Subject: Duke Energy Carolinas, LLC
William States Lee III Nuclear Station – Docket Nos. 52-018 and 52-019
AP1000 Combined License Application for the
William States Lee III Nuclear Station Units 1 and 2
Response to Request for Additional Information (eRAI 2563)
Ltr# WLG2012.07-01

**Lee Nuclear Station Supplemental Response to Request for Additional Information (RAI)
RAI Letter No. 068**

Reference NRC RAI Number(s): RAI 03.08.05-005

Figure 1. Rectangular Foundation Area

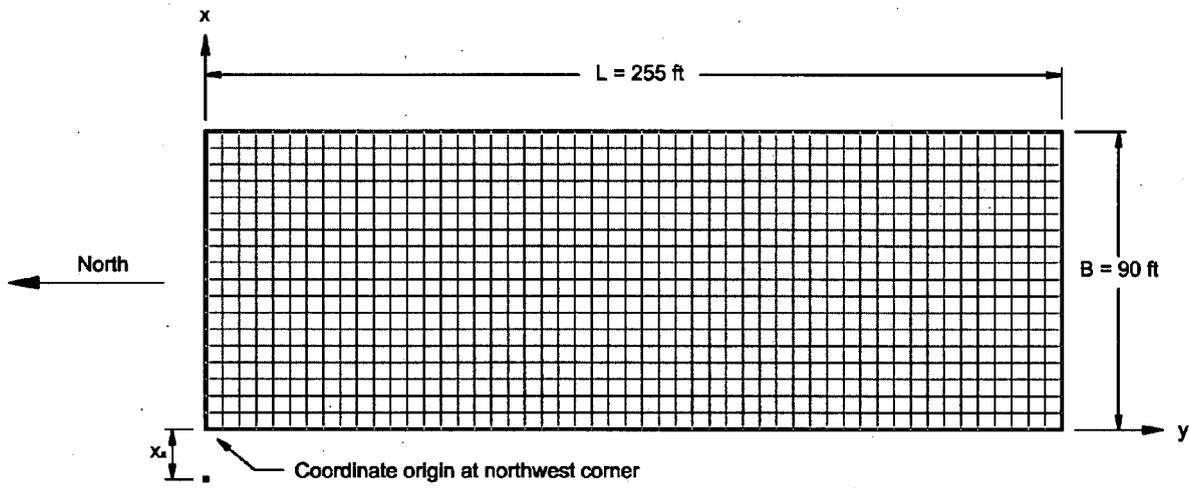
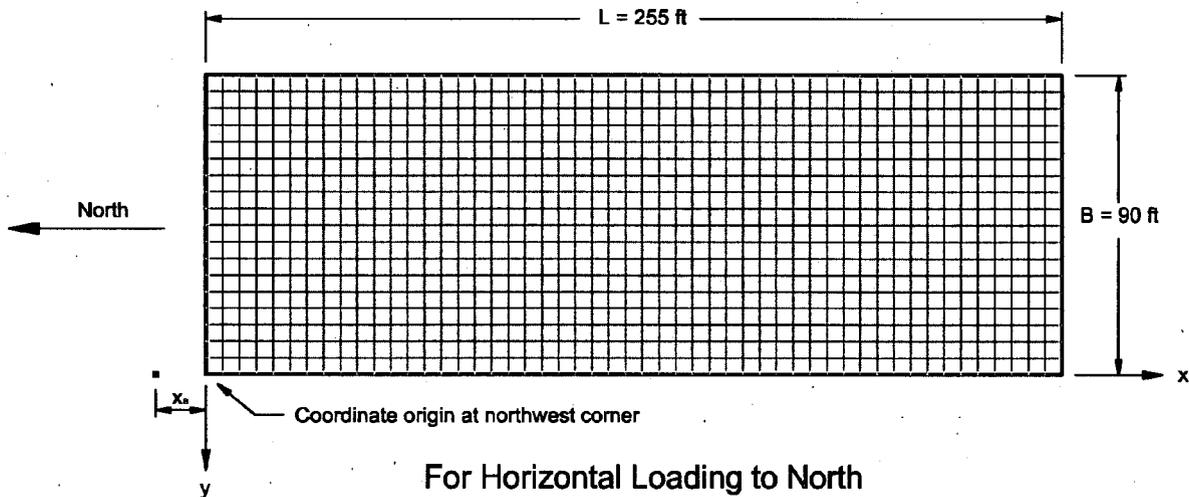
The use of benches appears to be a good way to provide a reliable load path to the rock. The text of the RAI response indicates benches will be formed at sloping rock. However the revised figures do not clearly require the formation of benches. Taking Note 2 of either figure literally, benches are required only if sloping rock does not meet the requirement for continuous rock (apparently RQD 65% per FSAR 2.5.4.11). Also, the angle at which a surface qualifies as "sloping" has not been established.

For loading to the north or to the west, an x-y-z rectangular foundation coordinate system, as depicted on Figures 1 and 2, was established for each direction with its origin at the corner of the nuclear island base mat and oriented so that the x-axis was always in the direction of the horizontal loading, with the z-axis always vertical and positive downward. Stresses were calculated at depths (z) below the bottom of the nuclear island ranging from 25 ft to the depth where each rock slope configuration intersected the outer slope of the concrete. For slope angles (alpha "α") equal to 1:1 (H:V) or steeper, the maximum depth was 50 ft; for flatter rock slope angles, the maximum applicable depth varied consistent with the depth where the rock slope angle intersects the outer slope (e.g. maximum depth = 25 ft for the flattest rock slope angle of 4:1 (H:V)). Equations from the theory of elasticity that compute the stress in the supporting medium for point loads on the surface as found in Poulos and Davis (1974) (Reference 5) and in Som and Das (2009) (Reference 6) were used to compute the normal and shear stresses induced by the horizontal and vertical foundation loads.

The equations for induced stresses are for point loads. The foundation area (Figure 1) is subdivided into small square sub-areas with the center of each square serving as the coordinate location of a point load representing the area load associated with that square. Sub-area squares, five ft by five ft, are used. The foundation area is represented by 51 rows of sub-area squares in the north-south direction, and by 18 rows in the east-west direction, for a total of 918 sub-areas covering a total area of 22,950 ft² (255 ft (north-south) by 90 ft (east-west)).

The rectangular shape and size of the foundation in Figure 1 are somewhat smaller than the full nuclear island area, but were chosen for calculation convenience, justified by the concept that seismic loading to the north or to the west concentrates the vertical loading toward these sides (e.g., see Figure 2.6-8 of TR-85, Revision 3) and that applied loads on the foundation area that is located far from the northwest corner are not contributors to the stress in the sloping fill concrete in that locality.

Figure 2. Section Model at Northwest Corner Lee Nuclear Station Unit 1

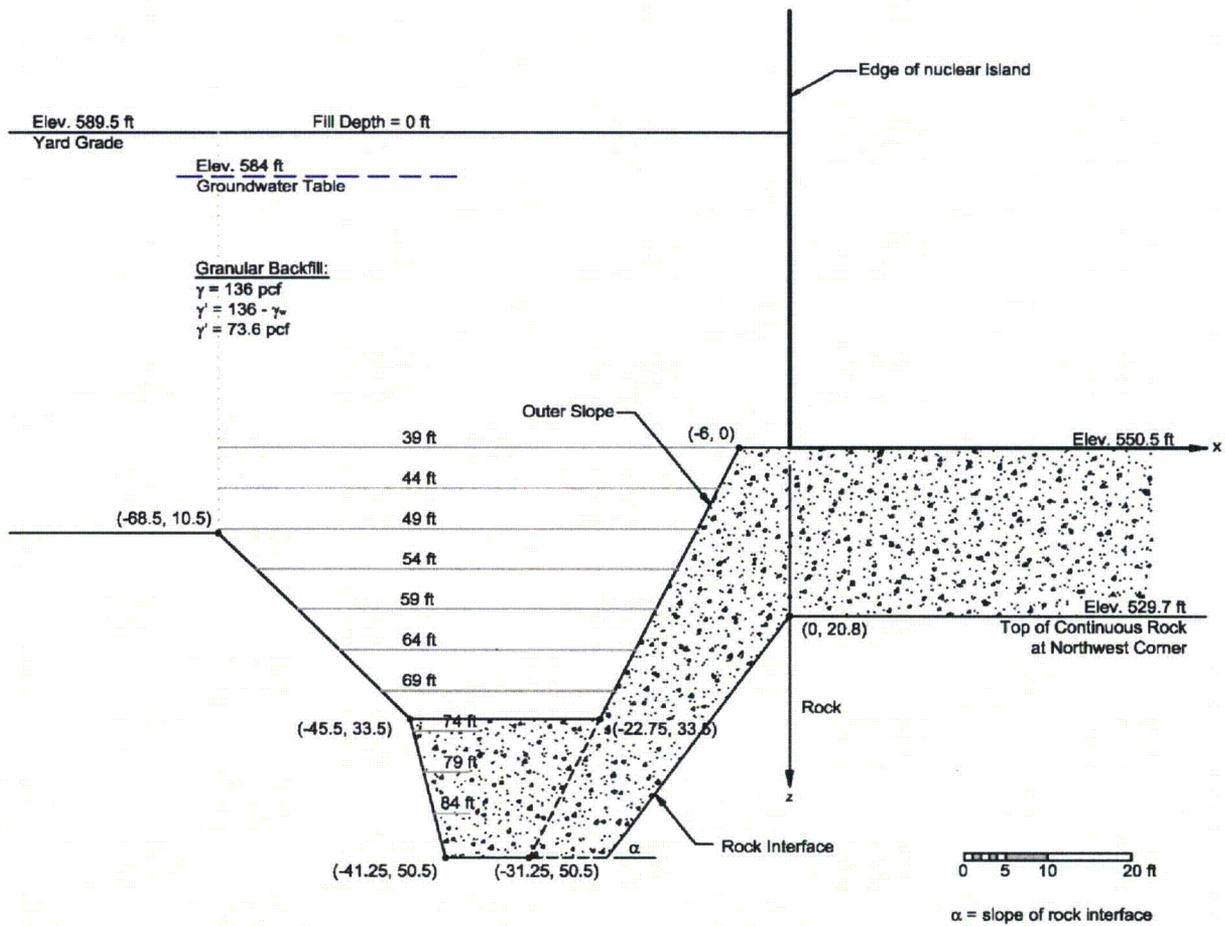
The fill concrete is an essential part of the foundation load path. Without a quantitative stress analysis that accounts for the sloping rock geometry, it is not apparent to the Staff that the margin of safety for the fill concrete in the northwest corner is acceptable.

2. An analysis has been performed to verify that stress in the fill concrete is acceptable. The assumptions about the post-excavation geometry of the continuous rock, including the maximum slope of the rock are described below. The continuous rock begins to slope at the northwest corner of the Unit 1 nuclear island and slopes down to the north and to the west. The top of the continuous rock slope was kept at elevation 529.7 ft (20.8 ft below the base of the nuclear island) and a range of continuous rock slope angles was postulated from the flattest (4:1 H:V) to the steepest (0.25:1 H:V). The outer slope of the fill concrete begins 6 ft north and 6 ft west of the nuclear island base mat and slopes downward to the north and to the west at (0.5:1 H:V) and connects with the sloping continuous rock at elevation 500 ft as it is depicted on revised FSAR Figures 2.5.4-245 and 2.5.4-246, except where the postulated continuous rock slope is flat enough to intersect the outer slope at a higher elevation than shown on these figures. The plan view of the analyzed foundation model is depicted on Figure 1. The cross section geometric model is depicted on Figure 2, where alpha "α" is the symbol given to the rock slope inclination.

For all calculations, the concrete unit weight and Poisson's ratio were 145 lb/ft³ and 0.17, respectively. The stresses induced by the weight of the adjacent granular backfill were calculated using equations in Carrier (2006) (Reference 7). The unit weight of the granular fill is shown on Figure 2.

Figure 3. Stresses in Fill Concrete at Outer Slope

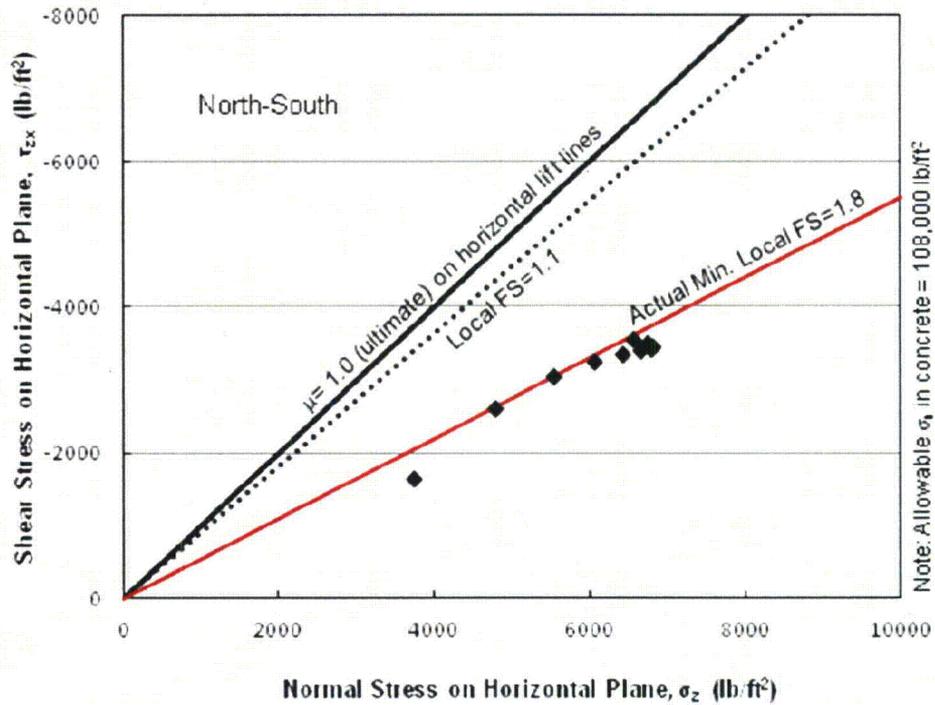
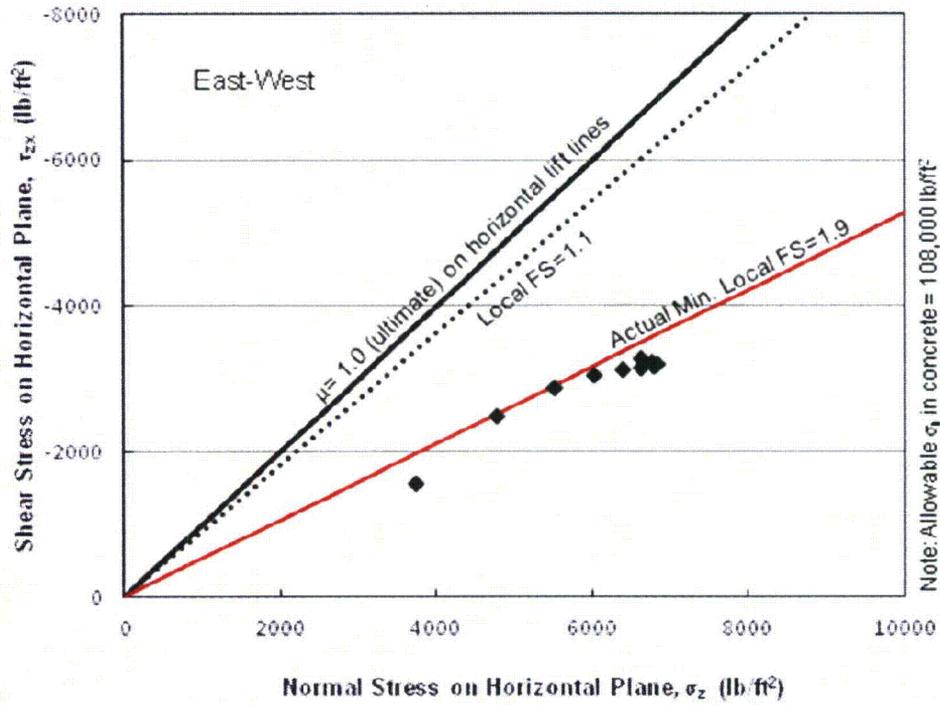
The RAI response also argues that shear stresses are not a controlling failure mode based on the calculations shown in the response for RAI 03.08.05-001. However, those calculations apply to a uniform layer of fill on non-sloping rock and may not be directly applicable.

- Revised Figure 3 depicts the normal (vertical) and shear stresses on horizontal planes along the outer slope of the fill concrete which is identified on Figure 2. Inspection of Figure 3 indicates the shear stresses on horizontal planes at the outer slope of the fill concrete are significantly below the descriptive criterion (local FS = 1.1).
